Punjab Masstransit Authority			
Minutes of Meeting			
Subject:	Pre-Bid Conference On Tender For Provision, Commissioning, Installation, Calibration, Integration, Testing, and Execution of IT Systems (CCTV Surveillance, Connectivity And Video Wall) For Metrobus System in Multan.		
Date:	March 01, 2015	Time:	10:30 am
Venue:	Committee Room, Punjab Masstransit Authority	Chair:	Mr. Muhammad Ozair Shah, General Manager Operations, PMA
Participants:	List of Participants: <ol style="list-style-type: none"> 1. General Manager Operations, PMA 2. Manager IT, PMA 3. IT Expert, PMA 4. Financial Specialist, PMA The list of prospective bidders who participated the Pre-Bid meeting is attached at Annex-A.

Addendum No1 to Tender Document

**PROVISION, COMMISSIONING, INSTALLATION, CALIBRATION,
INTEGRATION, TESTING, AND EXECUTION OF IT SYSTEMS (CCTV
SURVEILLANCE, CONNECTIVITY AND VIDEO WALL) FOR MULTAN
METROBUS SYSTEM**

ELEVATED STATION ICT TYPICAL DRAWING
CCTV (Power Conduit Layout)

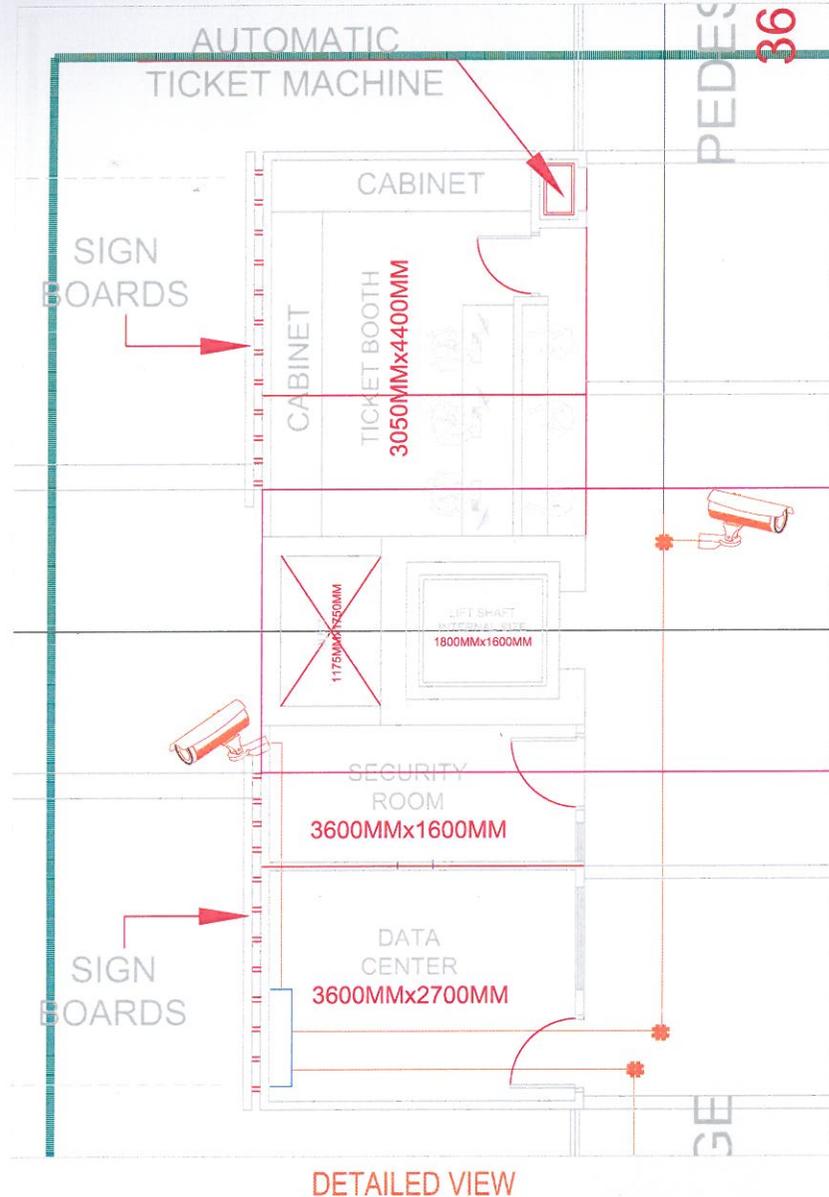
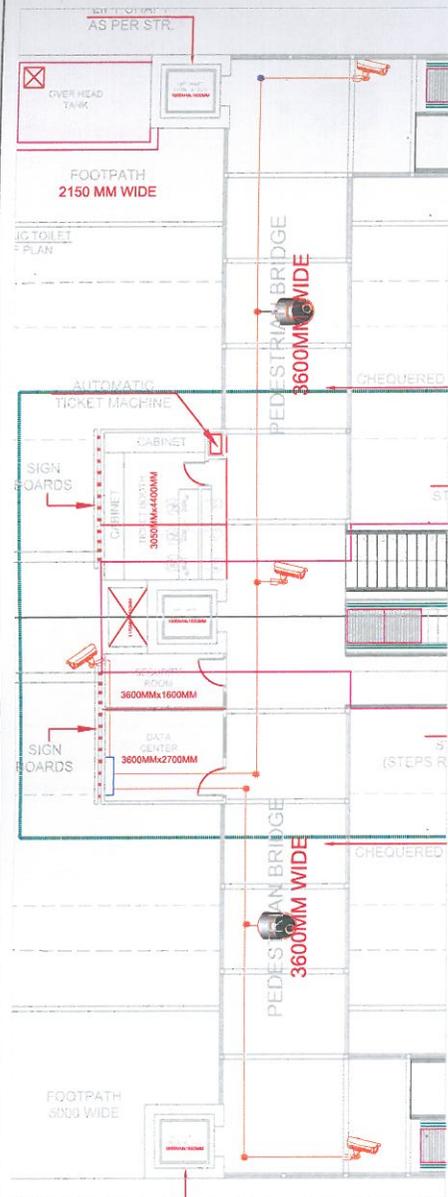
<p>11. M/s Inbox sought the clarification regarding Location of Data Cabinet and cameras</p>	<p>11. Self-explanatory station drawings are attached Annex-B depicting the location of Data Cabinet and Cameras.</p>
<p>12. M/s Inbox sought clarification about ducting responsibility in station to install the cameras.</p>	<p>12. It is clarified that conduits from the data cabin at station for various fixtures, like camera, turnstile, passenger information systems etc. are well covered in civil contract, incorporated in the design and construction drawings and are laid in the civil work of the platform. However selected bidder of the project will do all the cabling, wiring etc.</p>
